BAYOU BIENVENUE  
CONTROL STRUCTURE

PERIODIC INSPECTION REPORT NO. 5

CELMV-ED-GG (CELMN-ED-DG/19 Sep 88) (1105-2-10c) 3d End Mr. Stegall/j1/634-5900  
SUBJECT: Lake Pontchartrain, Louisiana and Vicinity, Chalmette Area Plan,  
Bayou Bienvenue Control Structure, Periodic Inspection No. 5

CELMV-ED-GG (CELMN-ED-DG/19 Sep 88) (1105-2-10c) 1st End Mr. Stegall/j1/634-5900  
SUBJECT: Lake Pontchartrain, Louisiana and Vicinity, Chalmette Area Plan,  
Bayou Bienvenue Control Structure, Periodic Inspection No. 5

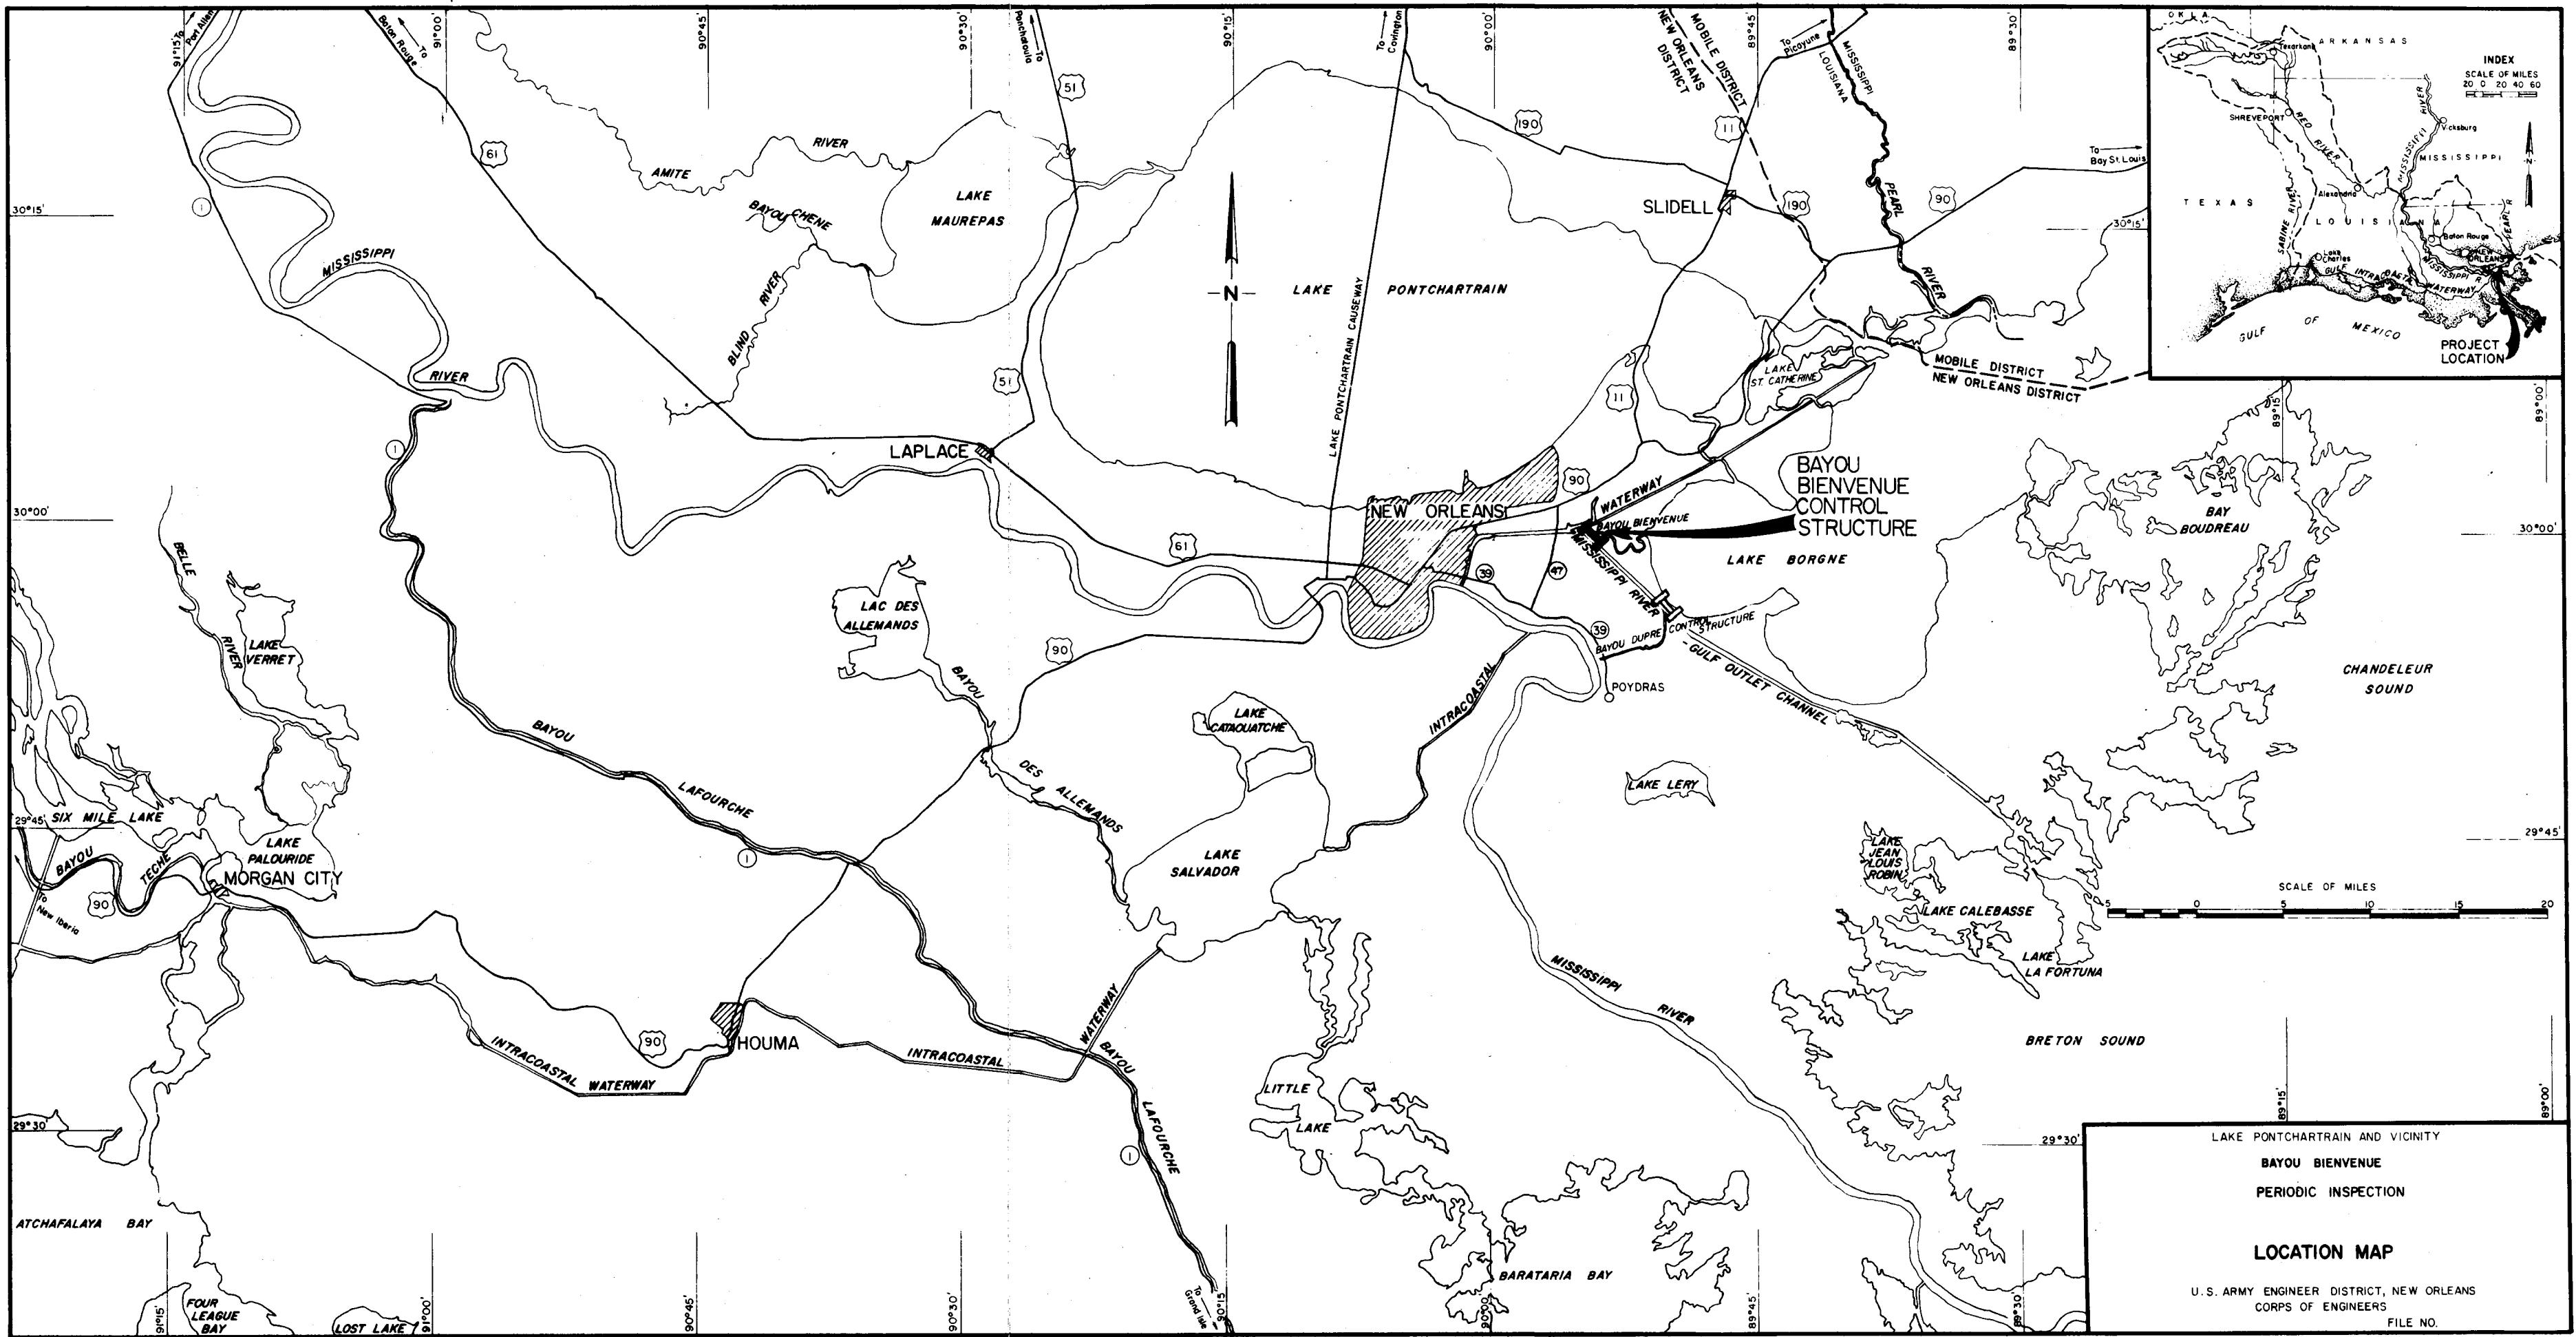
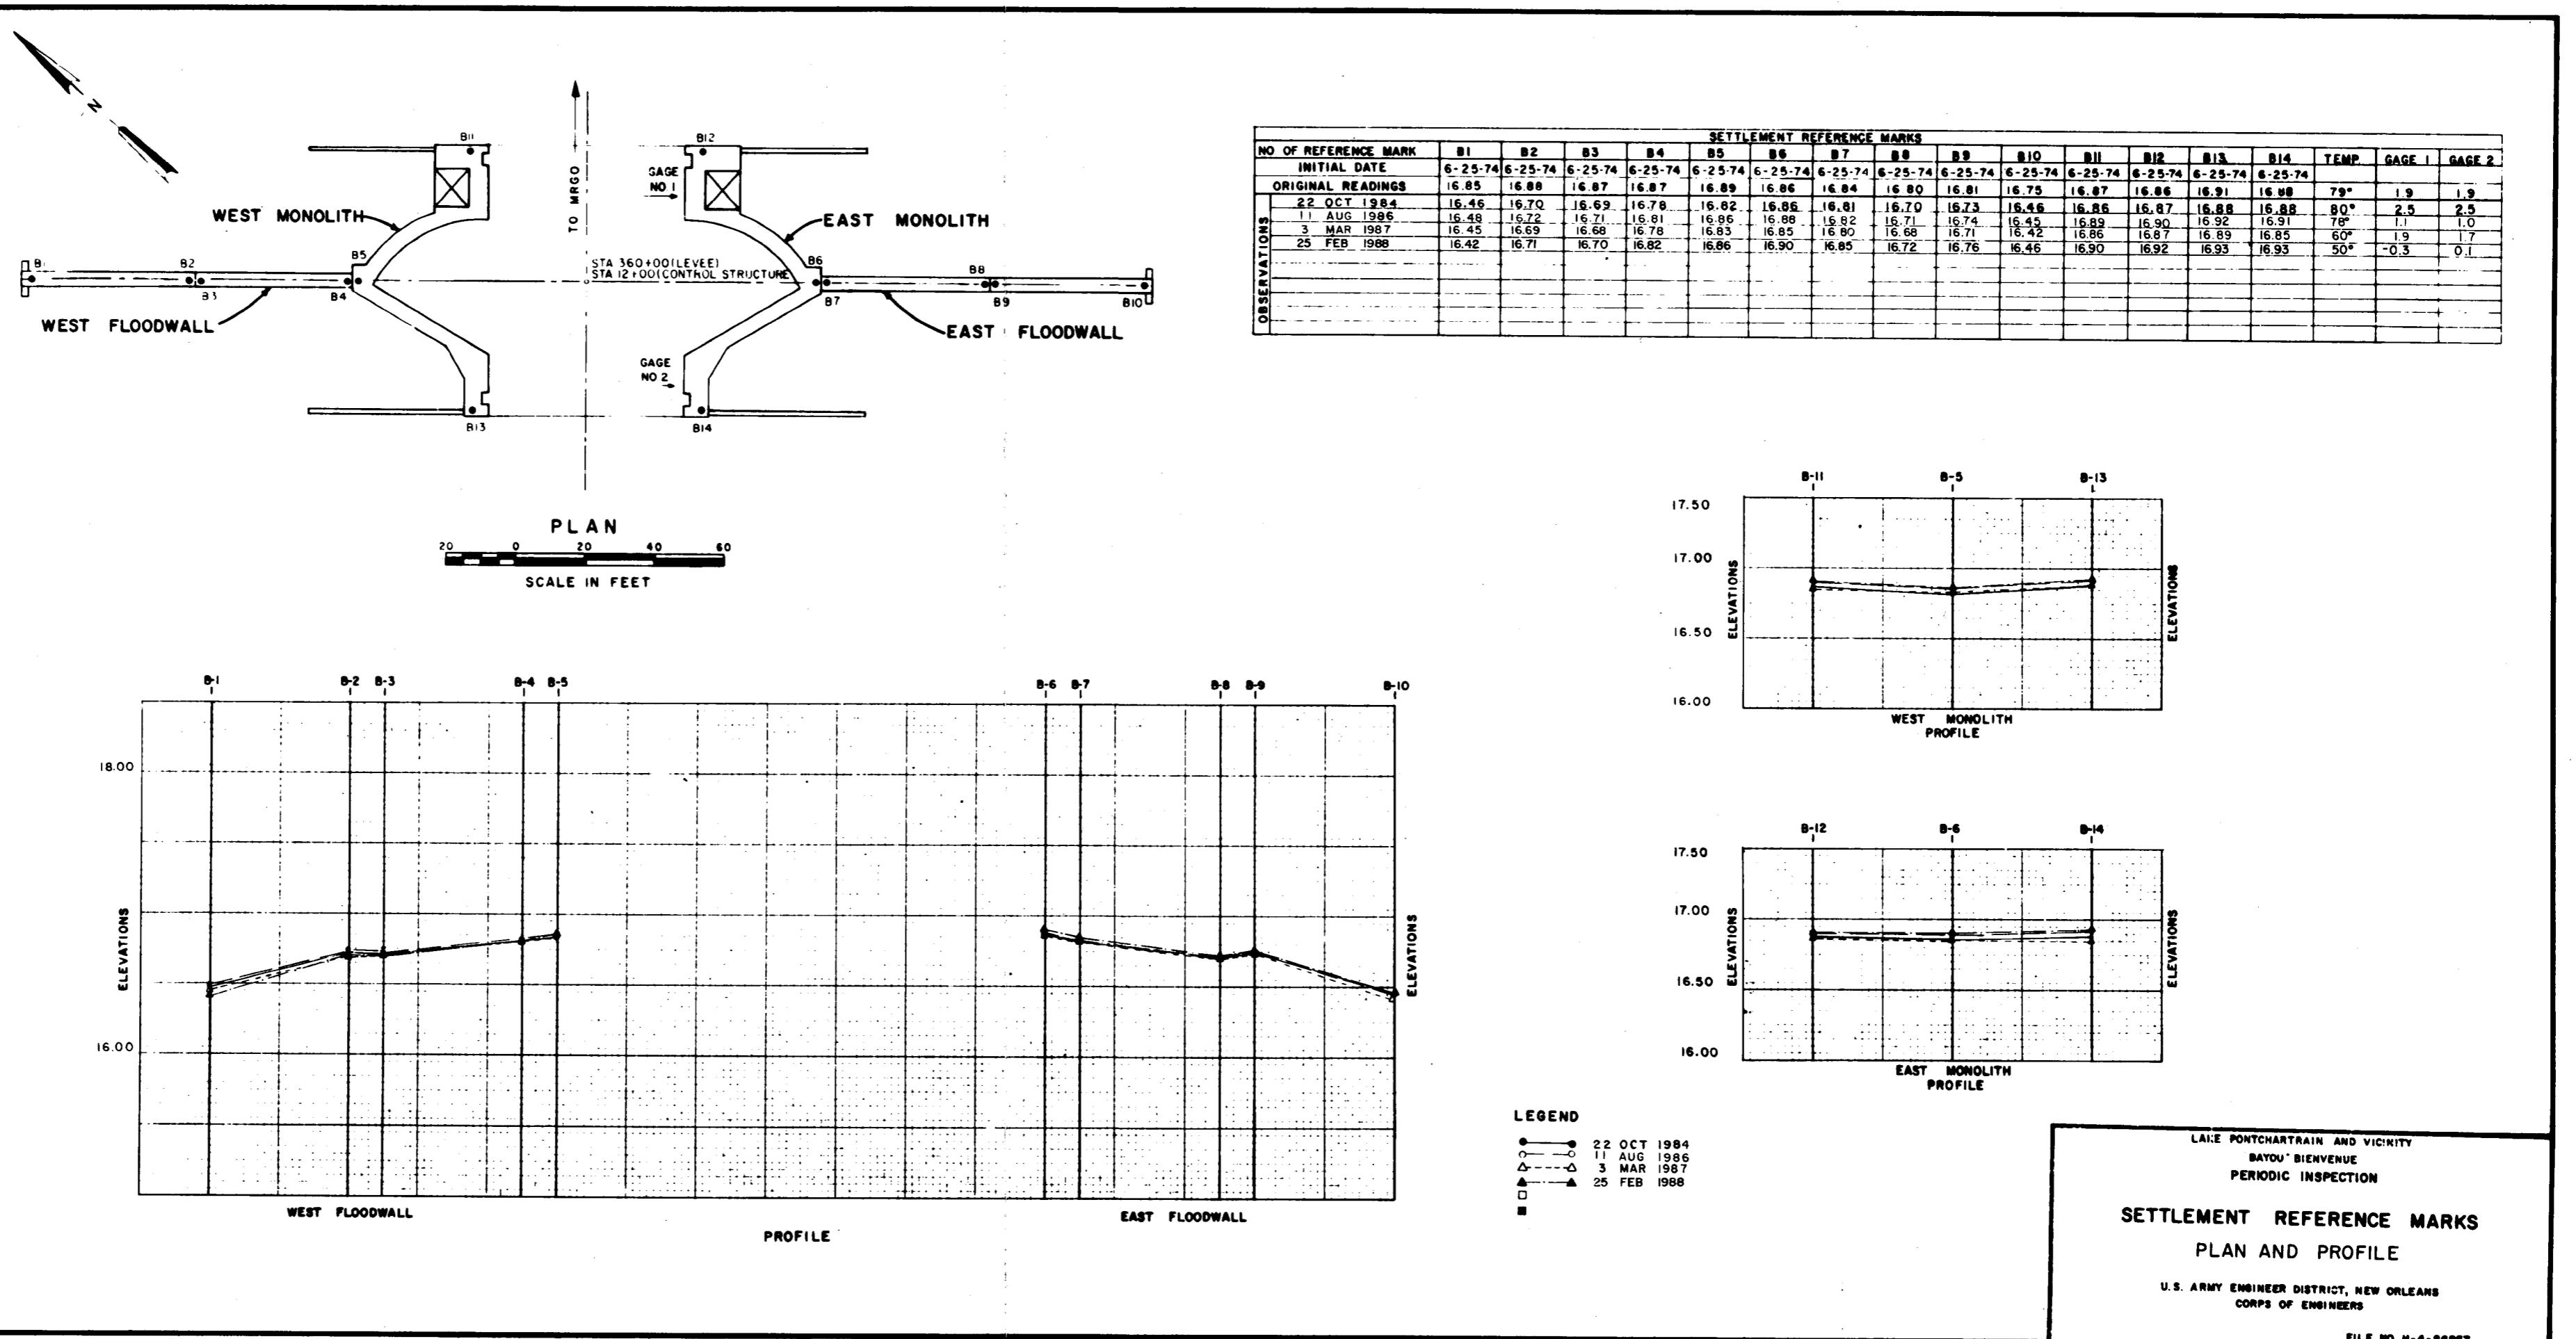
a. Para 4-03b, page IV-1. Refer to comment marked in red which should be made in your file copies of this report.

a. Para. 4-03b, page IV-1. The comment has been corrected  
in our file copy of this report.
